South Texas Project  
Units 1 and 2  
Docket Nos. STN 50-498, STN 50-499  
Request for Additional Information for the  
Review of the South Texas Project License Renewal Application  
(TAC Nos. ME4936 and ME4937)

**STPNOC License Renewal Application Response to Request for Additional Information**

**RAI B2.1.37-8****Background:**

Figure 1 - TOFD principle

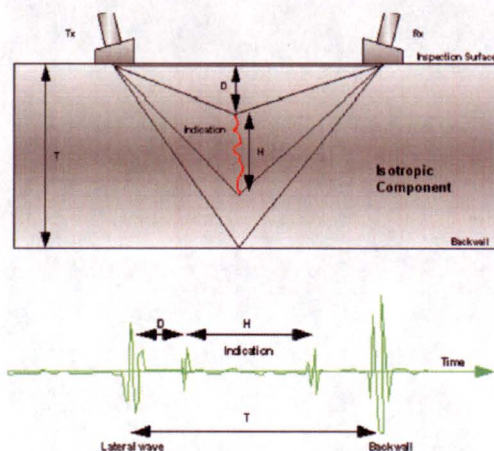
2. State the following in relation to the UT technique capable of characterizing the extent of selective leaching in aluminum bronze welds:
  - a. A description of the method.
  - b. How the effectiveness of the technique will be demonstrated.
  - c. Type of information and resolution provided by the technique.
  - d. The qualifications of the individuals conducting the examinations and evaluating the examination results.

An ultrasonic (UT) Time-of-Flight Diffraction (TOFD) technique for examining aluminum/bronze (Al-Bz) cast base material was proven to be an effective and reliable tool for detection and characterization of selective leaching. In a TOFD system, a pair of ultrasonic probes sit opposite each other. One of the probes (transmitter) emits an ultrasonic pulse that is received by the opposite probe (receiver). Three primary wave types are used in a TOFD technique: lateral wave, backwall reflection, and tip diffraction (Figures 1 and 2 below). One or more of these wave types can be used to detect selective leaching. Increased backwall reflection, detection of tip signals, and lack of lateral wave detection are indications of potential selective leaching.
